Access Compliance Report

Public Rights-of-Way

(Curb Ramps)

Intersection ID: 15195	Main Street: ALBEMARLE_RD	Cross Street: FARM_POND_LN	Location: SE
ADA ID: D8402F6D45BB	Ramp Type: Perp	Initial Pass/Fail: Fail	Overall Compliance: No
Codes/Mitigation Info/Possible Solution		Field Measurements/Component Compliance	
Severity Score: 22.5

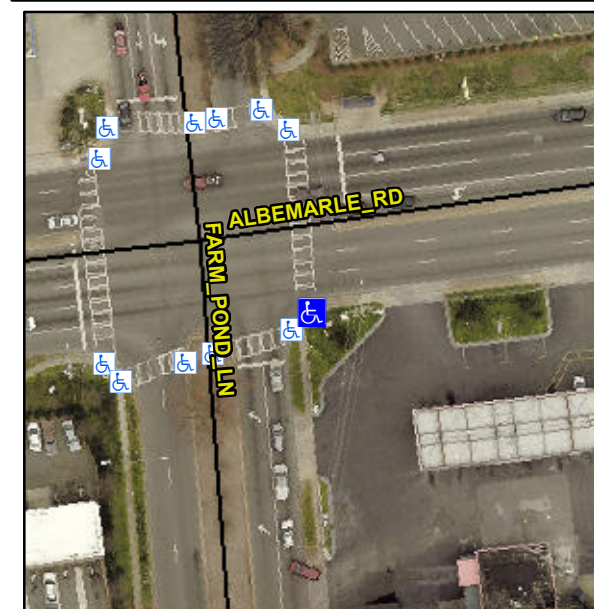
Not Found, R304.5.1, R304.2.2, R304.5.3

Compliance	Description	Data	Compliance	Description	Data
N/A	Ramp Length (in)	58.0	No	Ramp Slope (%)	9.3
No	Ramp Width (in)	41.0	No	Ramp XSlope (%)	4.4
N/A	Flare Type LT	N/A	N/A	Flare Type RT	N/A
N/A	Flare Slope LT (%)	N/A	N/A	Flare Slope RT (%)	N/A
N/A	Flare Traversable LT?	N/A	N/A	Flare Traversable RT?	N/A
N/A	Landing Length (in)	N/A	N/A	DWS Provided?	N/A
N/A	Landing Width (in)	N/A	N/A	DWS Contrast?	N/A
N/A	Landing Slope (%)	N/A	N/A	DWS Length (in)	N/A
N/A	Landing X Slope (%)	N/A	N/A	DWS Full Width?	N/A
N/A	Landing Curb? (Y/N)	N/A	N/A	DWS Offset (in)	N/A
N/A	Shared Landing?	N/A			
N/A	Gutter Ponding?	N/A	N/A	Gutter Slope (%)	N/A
N/A	Gutter Lip Ht (in)	N/A	N/A	Gutter X Slope (%)	N/A
N/A	Painted X Walk1?	Yes	N/A	Painted X Walk2?	N/A
	X Walk 1 Direction	To N		X Walk 2 Direction	N/A
N/A	X Walk 1 Width (in)	110.0	N/A	X Walk 2 Width (in)	N/A
	X Walk 1 Slope (%)	7.5		X Walk 2 Slope (%)	N/A
	X Walk 1 X Slope (%)	0.5		X Walk 2 X Slope (%)	N/A

Remove & Replace Entire Ramp.
